Combined CD comment Responses.pdf Markup Summary

Subject: Line
Page Label: [4] 4 Site Plan
Author: Laura Besler

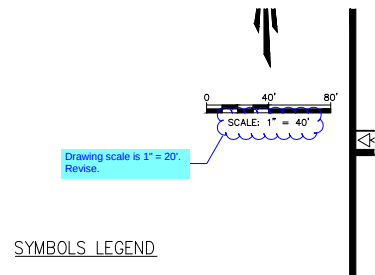
PROPOSED HEAVY
DUTY CONCRETE

ASPHALT

TAIT Response:
Note has been updated to "Asphalt"

Subject: Cloud+
Page Label: [29] 29 Offsite Sidewalk Horizontal Control Plan
Author: Laura Besler

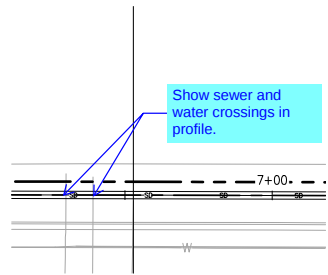
Drawing scale is 1" = 20'.
Revise.

TAIT Response:
Drawing scale has been updated

Subject: Callout
Page Label: [32] 32 Offsite Storm P&P
Author: Laura Besler

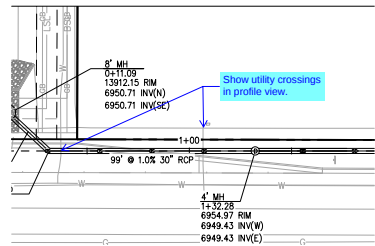
Show sewer and water crossings
in profile.

TAIT Response:
Utility crossings have been shown in the profile

Subject: Callout
Page Label: [1] 34 Offsite Storm P&P 3
Author: Laura Besler

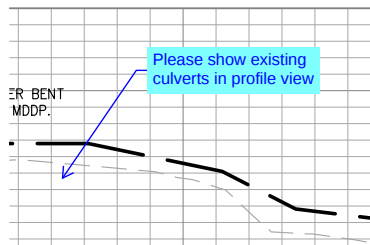
Please show 100-year HCL along entire section of pipe.

TAIT Response:
 HGL line has been shown through entire pipe section

Subject: SW - Textbox
Page Label: [6] 6 Site Details 1
Author: EPC Stormwater- Zachary

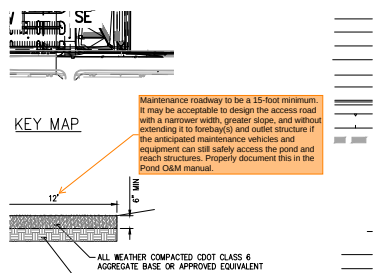
Consider having control joints every ~10ft

TAIT Response:
Note has been updated to add control joints every 10ft

Subject: SW - Textbox with Arrow
Page Label: [12] 12 Southeast Grading Plan
Author: EPC Stormwater- Zachary

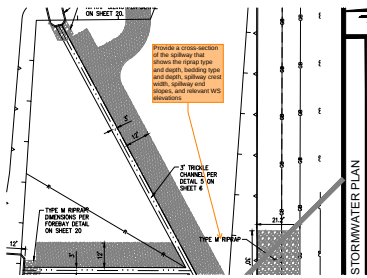
Maintenance roadway to be a 15-foot minimum. It may be acceptable to design the access road with a narrower width, greater slope, and without extending it to forebay(s) and outlet structure if the anticipated maintenance vehicles and equipment can still safely access the pond and reach structures. Properly document this in the Pond O&M manual.

TAIT Response:
Spec sheet for a common maintenance vehicle has been added to the O&M manual. The maintenance vehicles is only 8' wide and can traverse the 12' wide path. Per Drainage Criteria Manual Volume 2 Item 10, the maximum longitudinal slope on an access path is 10%, which the designed access path is underneath.

Subject: SW - Textbox with Arrow
Page Label: [15] 15 Stormwater Plan
Author: EPC Stormwater- Zachary

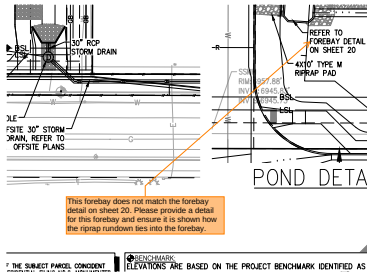
Provide a cross-section of the spillway that shows the riprap type and depth, bedding type and depth, spillway crest width, spillway end slopes, and relevant WS elevations

TAIT Response:
 Spillway Cross section has been added

Subject: Engineer
Page Label: [36] 36 Offsite Signage and Striping Plan
Author: Bret Dilts - DPW Engineering

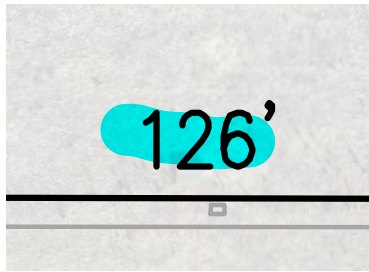
Include sizing for all signs

TAIT Response:
Added sign sizing.

Subject: Engineer
Page Label: [36] 36 Offsite Signage and Striping Plan
Author: Bret Dilts - DPW Engineering

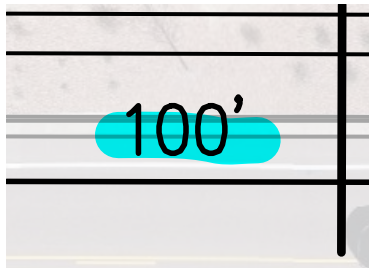
1000' per comments on the TIS

TAIT Response:
Updated the sign placement and distances.
